# INFILL INCENTIVE DISTRICT DESIGN PACKAGE for 1 WEST BROADWAY

1 JULY 2015

DEVELOPMENT PLAN PACKAGE SUBMITTAL

LEVEL ONE - PARKING  
1" = 20'-0"

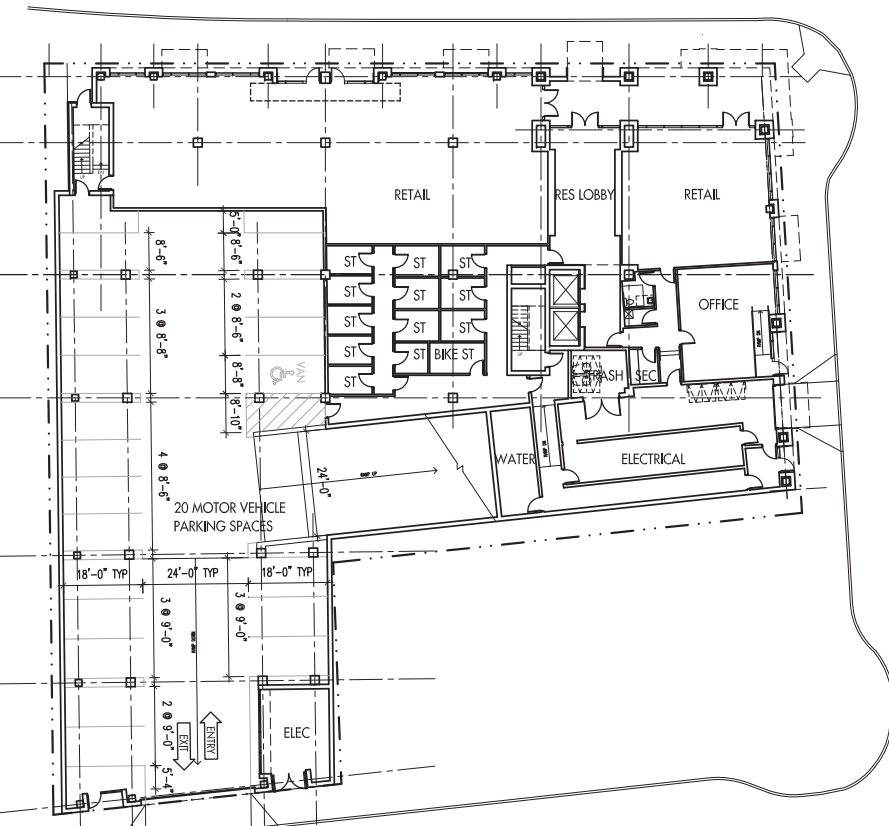
1) Please provide verification that the proposed level 1 parking space complies with all of the requirements of ICC A117.1-2009 Section 502 (i.e. required width, column obstruction, etc.).

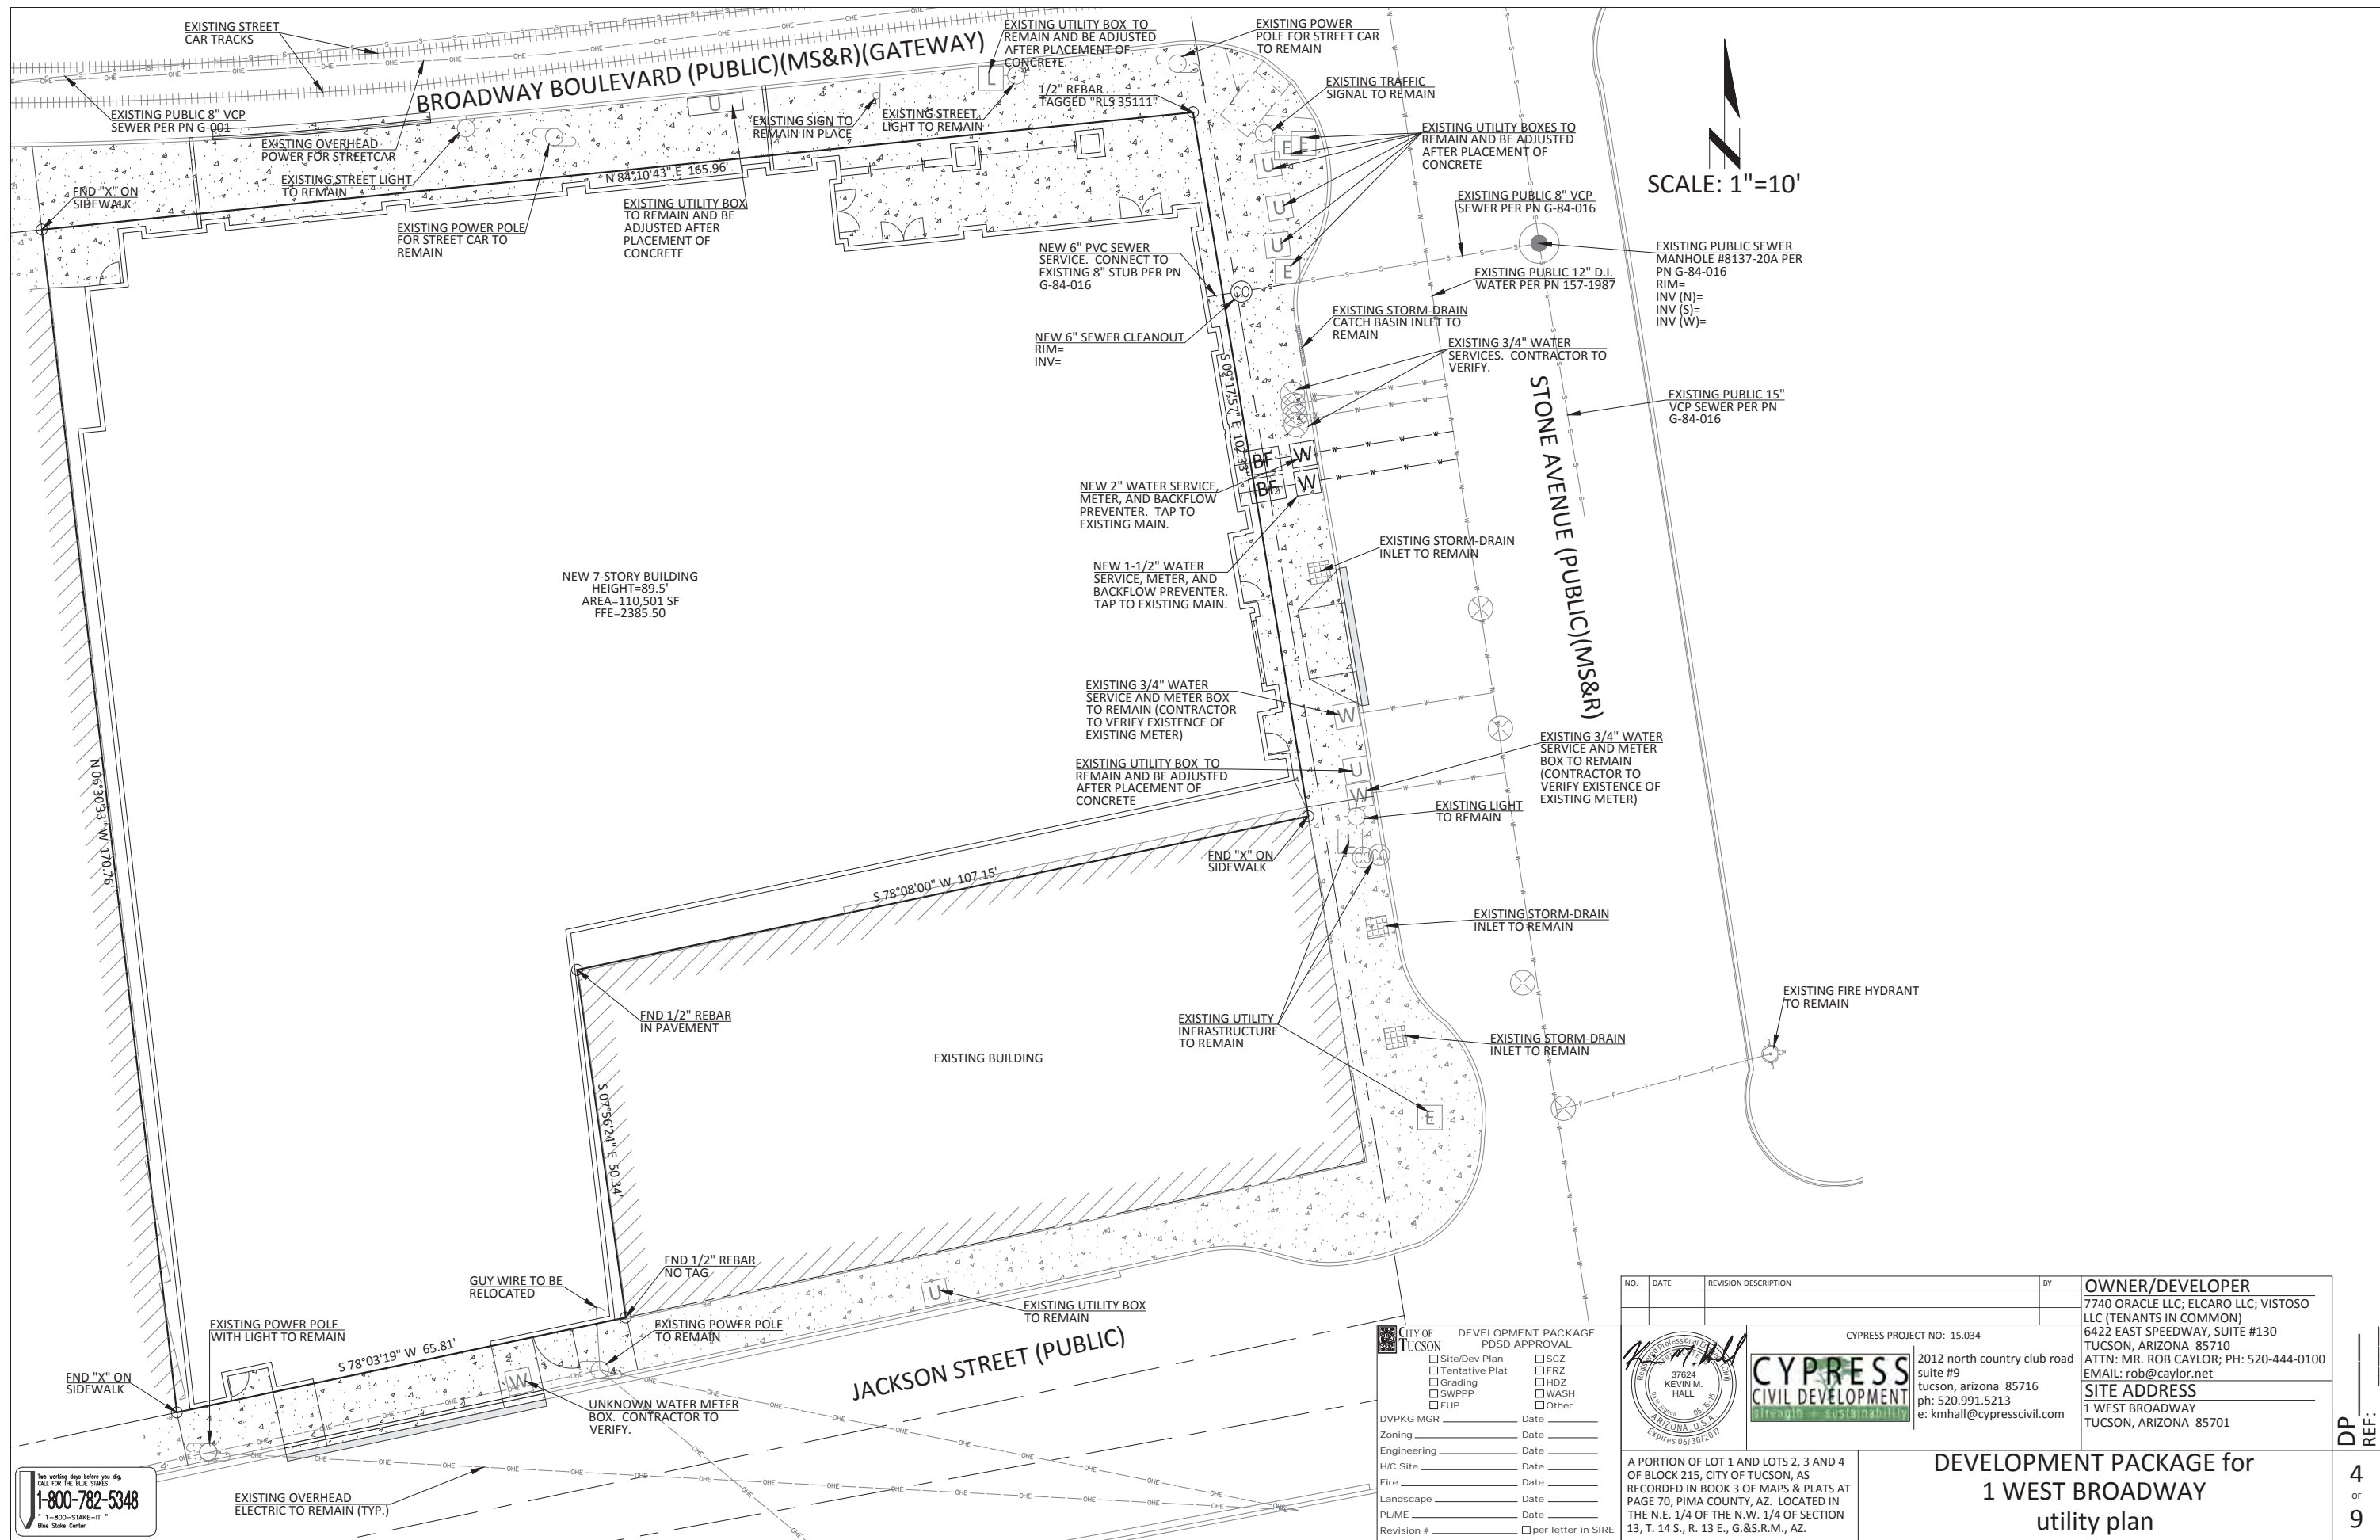
21) COMMENT: Provide the height and gross floor area within the footprint of the building on sheet 1.

24) COMMENT: It does not appear that the entire structure is shown on sheet 1, i.e. the southern parking area and entrance off of Jackson.

1. Keynote 12 on Sheet 1 of 9 shows the apron for service to be on the sidewalk. Provide a minimum 20 ft. x 10 ft. concrete apron, 6 inch thick, 3,000 psi with #4 rebar 12" OC within the loading area for the containers and the truck front wheels to be on during servicing.

2. Revise Keynote 6 on Sheet 1 of 9 to state "Building Owner's facility personnel shall be responsible for positioning the solid waste and recycling containers within the eastern portion of building on the days of service collection, and shall roll the containers out clearly onto the service apron in the loading area when the service vehicle arrives and shall roll the containers back into the building after servicing so that the service vehicle operator remains in the service vehicle".

3. Add a keynote on Sheet 1 of 9 stating signage will be added alongside the service vehicle and apron spaces within the loading area designating no parking between 7 AM and 8 AM weekdays.

**DEVELOPMENT PACKAGE for  
1 WEST BROADWAY  
utility plan**

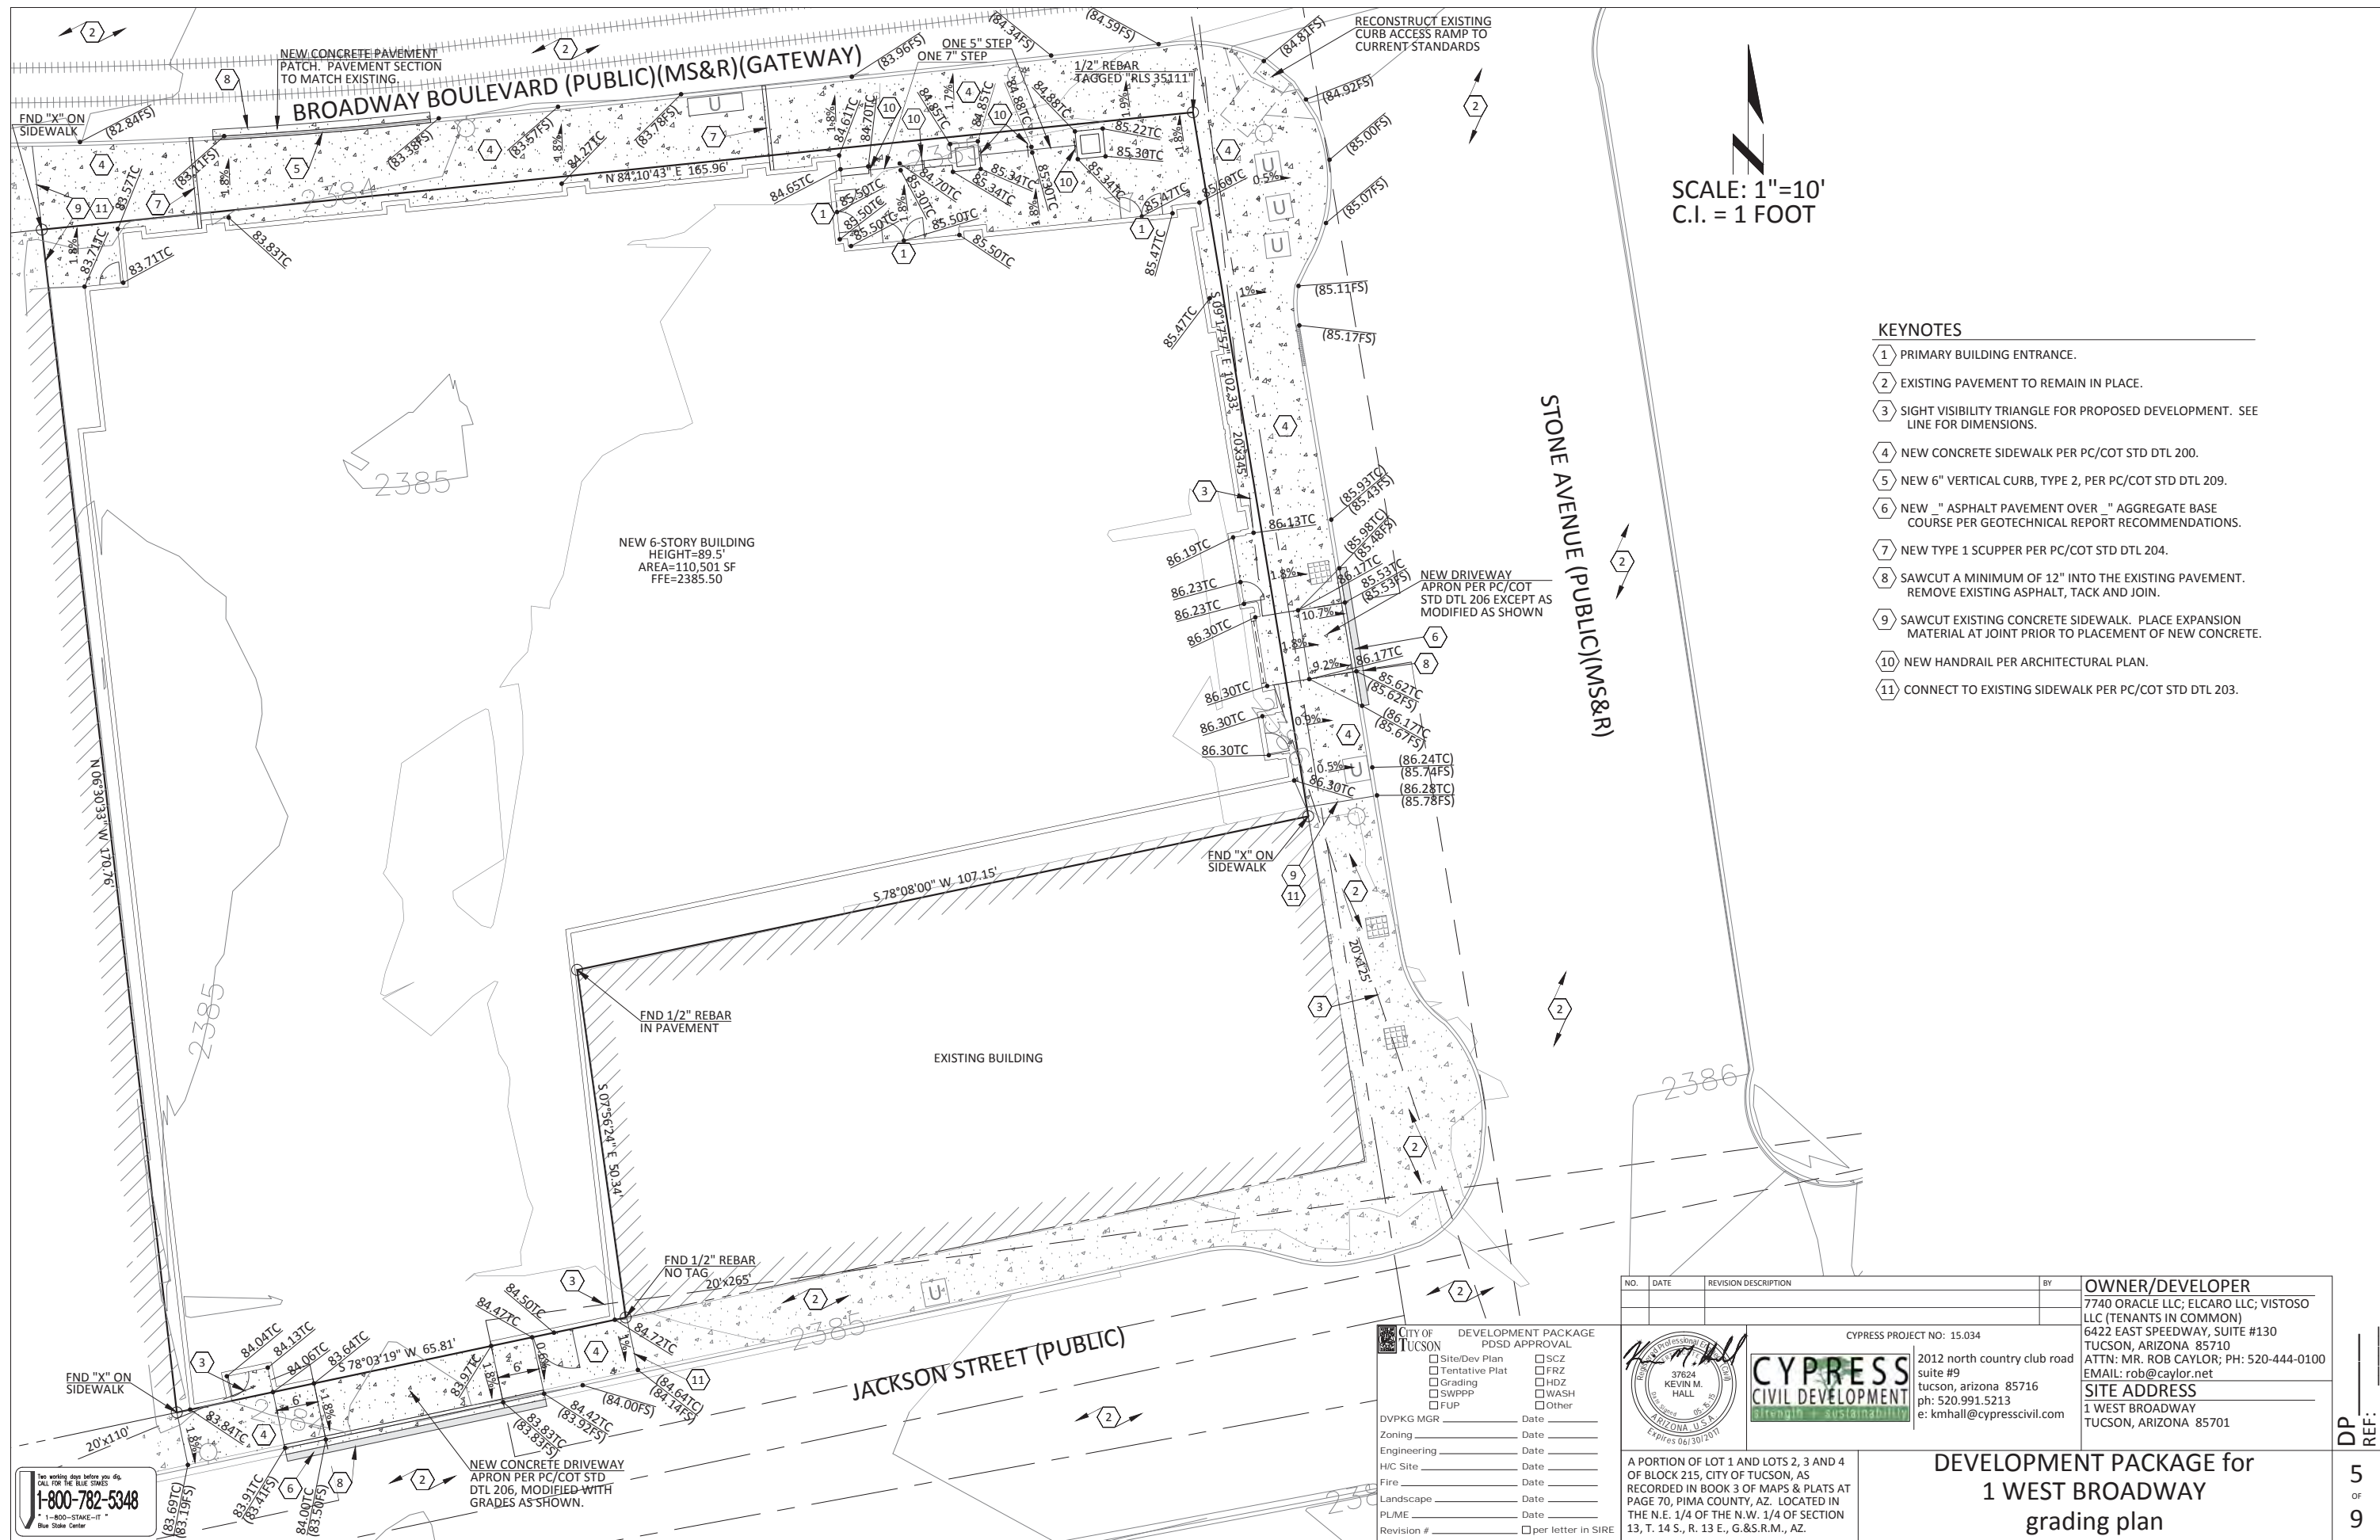
- 8) AM Sec.2-06.4.8.F: Revise the development plan package to label all existing storm drainage facilities on and adjacent to the site with the Improvement Plan Number in plan view. Clarify the existing storm drain inlets shown on Sheet 4, per the landscape plans these are to act as tree wells.

22) COMMENT: Sheet 4 shows the proposed height of the building as "89.5'" sheet 1 under "ZONING" lists the building height has 89'-3", clarify the difference.
